COM and Tx specifications

In support of comment 98

Charles Moore, Avago Technologies
2013 July 8

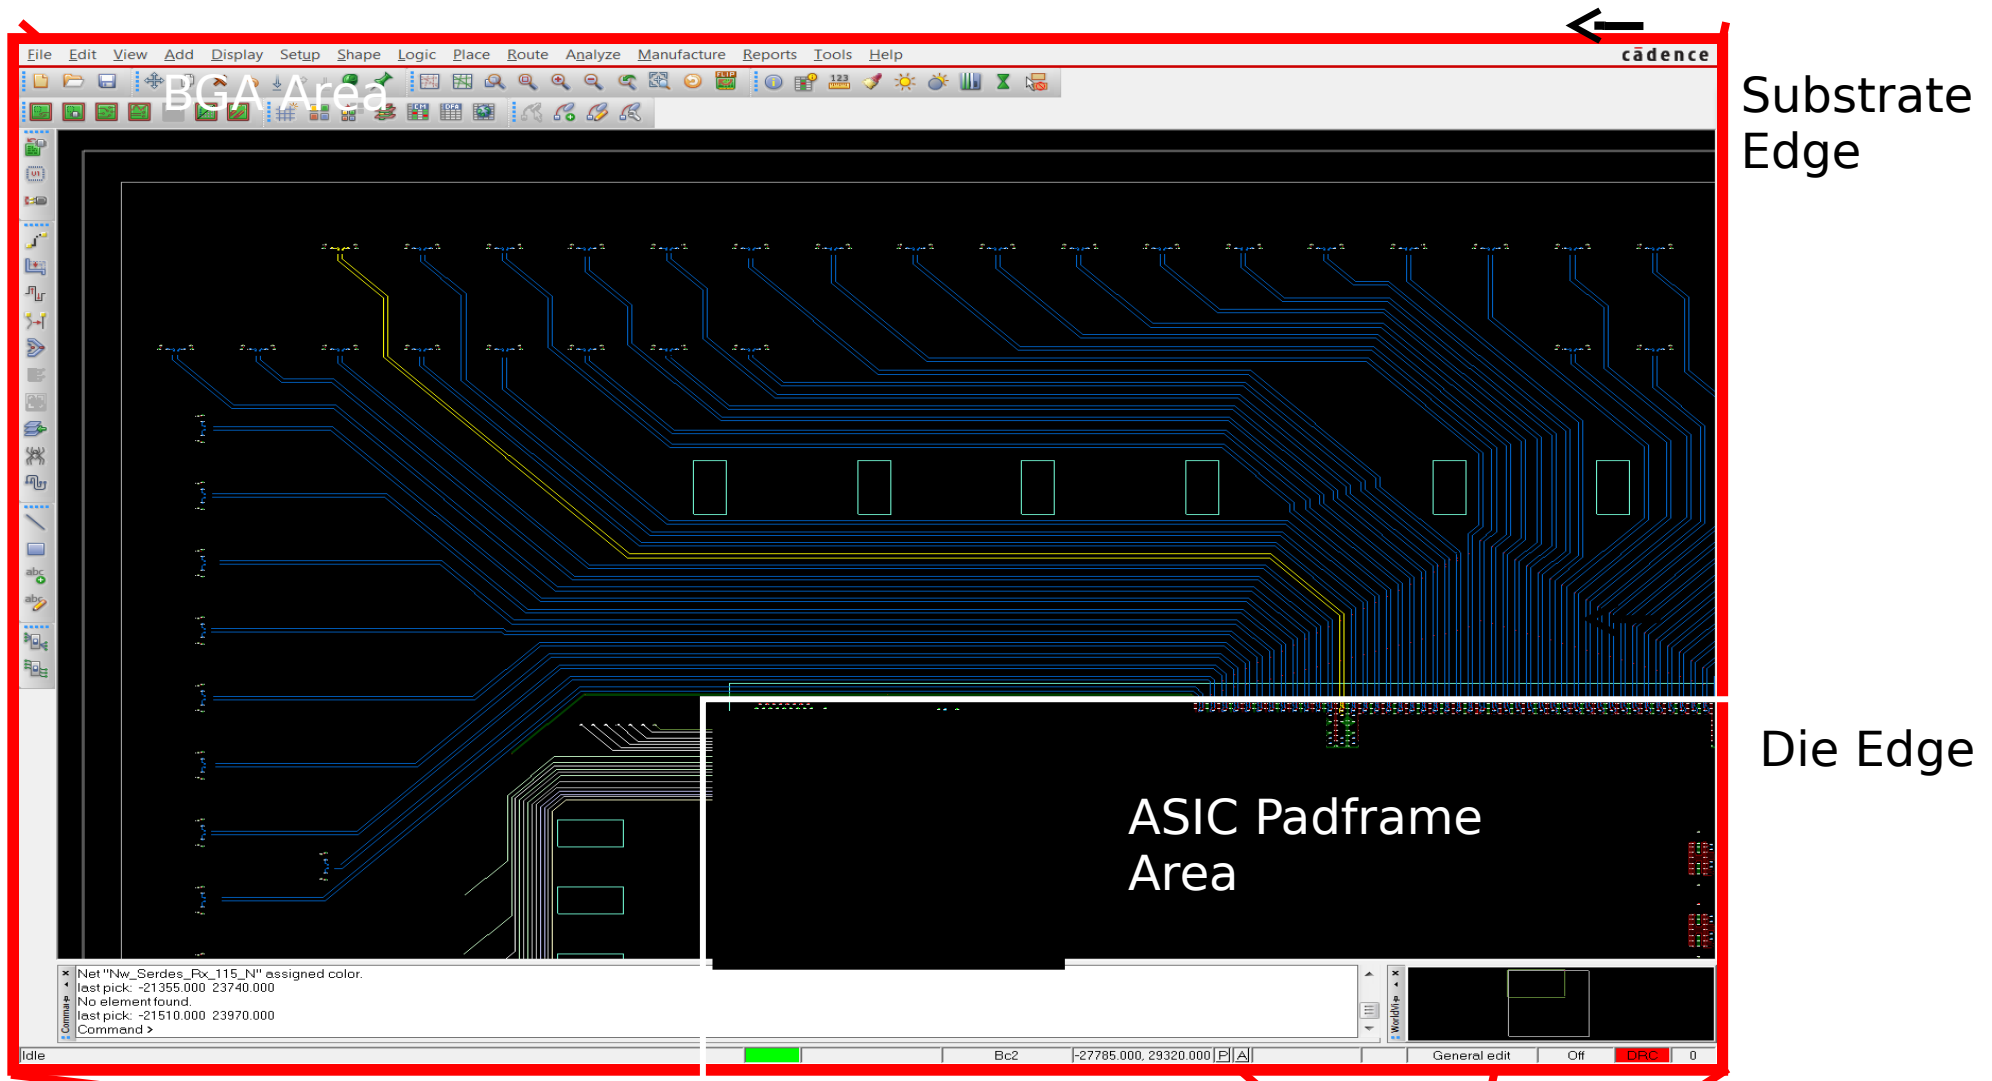
My first approach was to see if I could get any guidance from the minimum rise time spec. I did simulations to see what rise time did for various channels of general interest. Starting with a 1ps rise time input to some sub-minimal channels:

So with a minimum test fixture and the standard measurement filter and no package, the rise time already exceeded the specified minimum rise time for Clause 92 and 93 and when I added a 12 mm package trace, but no capacitance, the rise time exceeded the minimum for Clause 94. So the minimum rise time specs did me no good.

Since they can never be violated the specs do not seem to do anyone any good so I suggest that we eliminate: Clause 92.8.3.5, Clause 93.8.1.5, and Clause 94.3.12.5.

With 12mm package

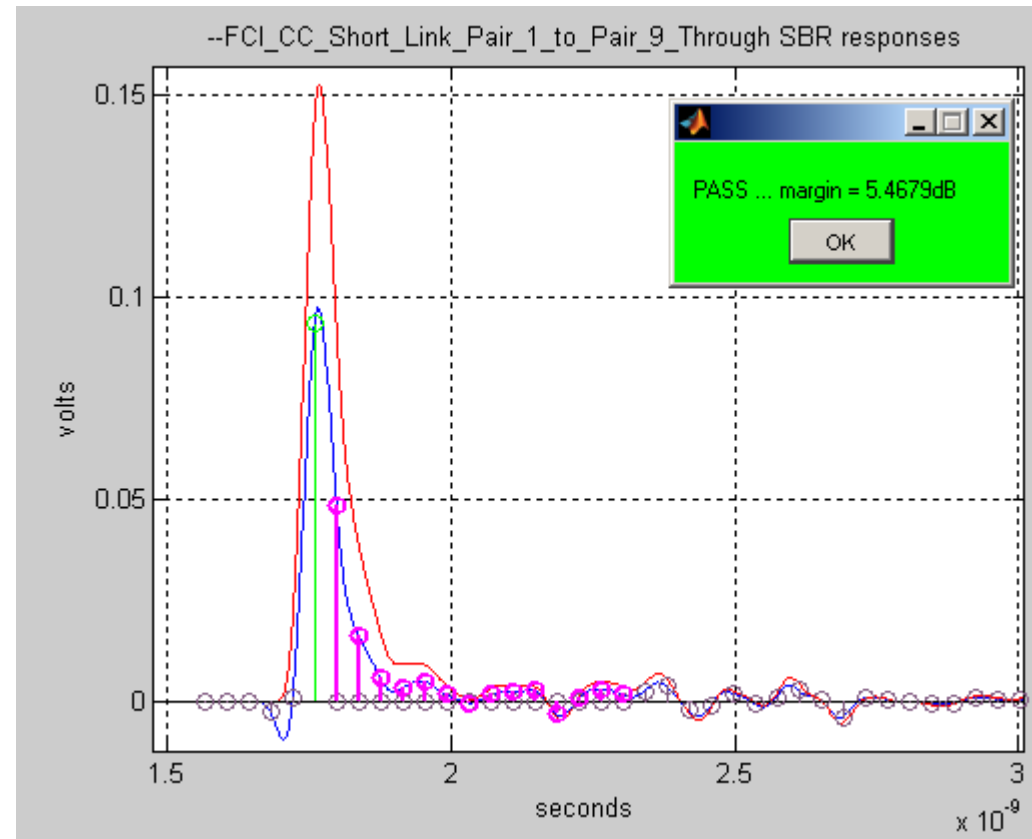
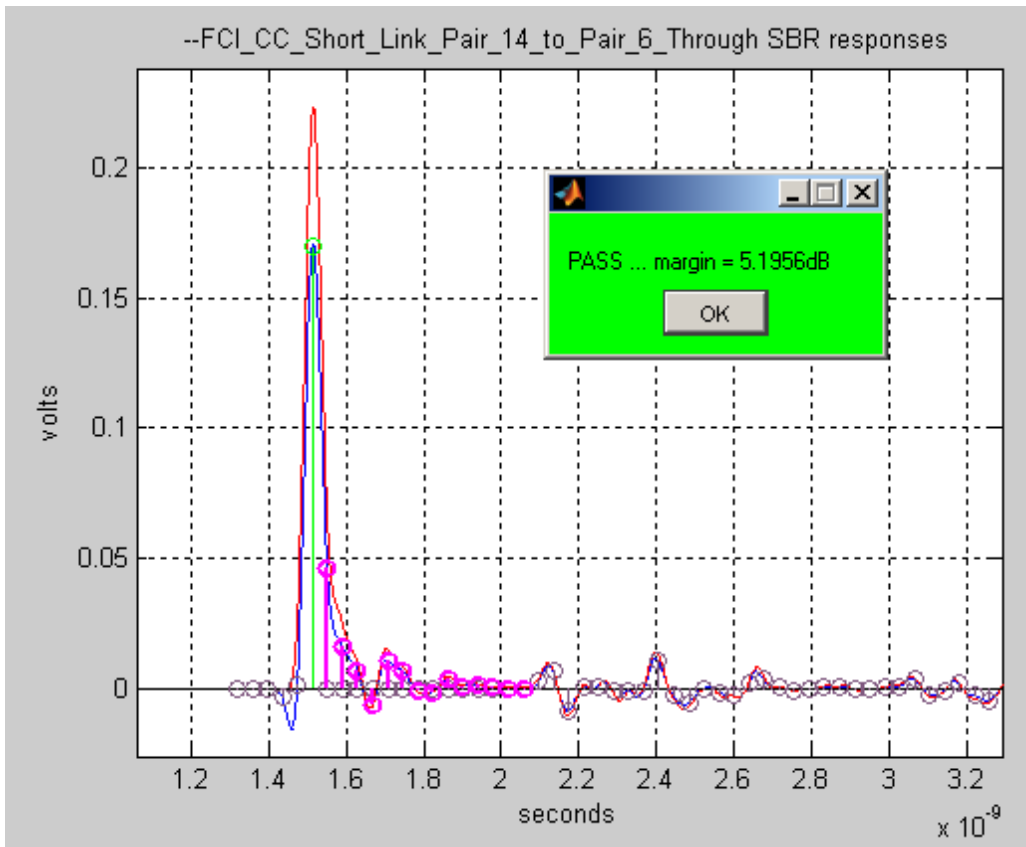
The question arises: how much channel reach does adding a longer package cost us. The answer is not simple. Liav Ben-Artzi points out that the longer package will produce a better return loss reducing some ISI while attenuating crosstalk and channel ISI as much as the signal. This can result in some channels actually working better with the longer package trace while other will work worse.

Loss of peak amplitude is compensated by lower ISI noise

With 12mm package

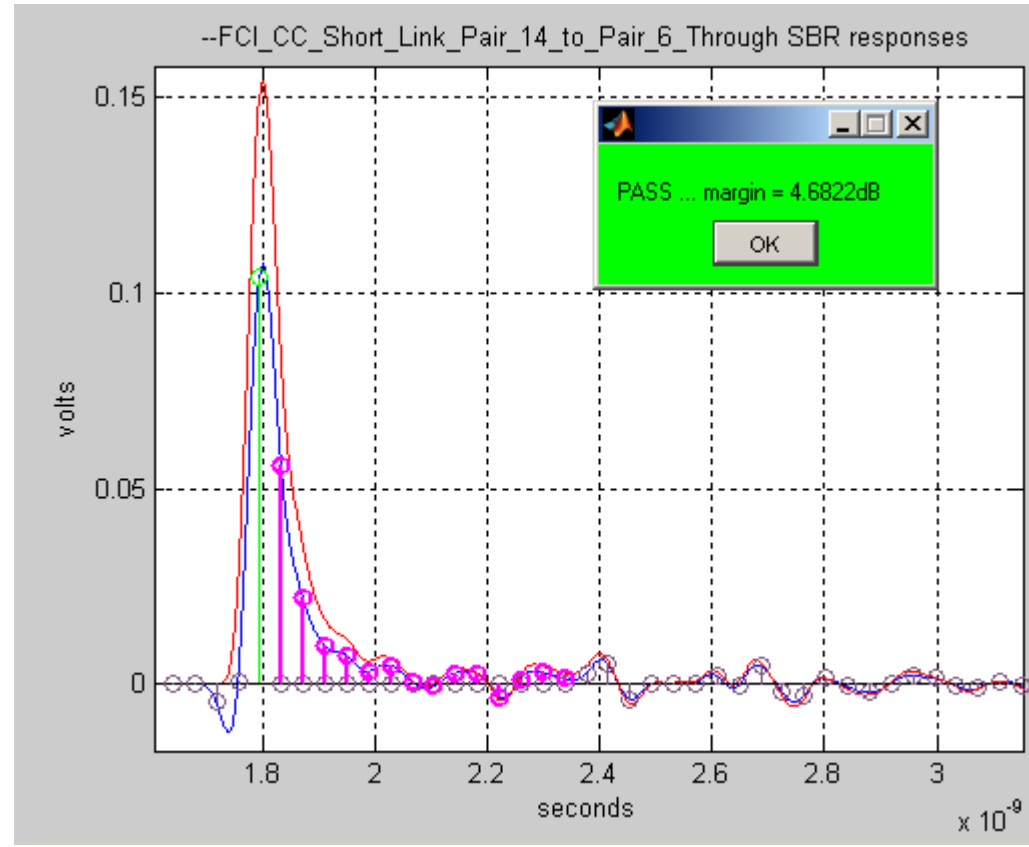
The previous slide showed a case where the longer package helped here is does not.

Loss of peak amplitude is not sufficiently compensated by lower ISI noise
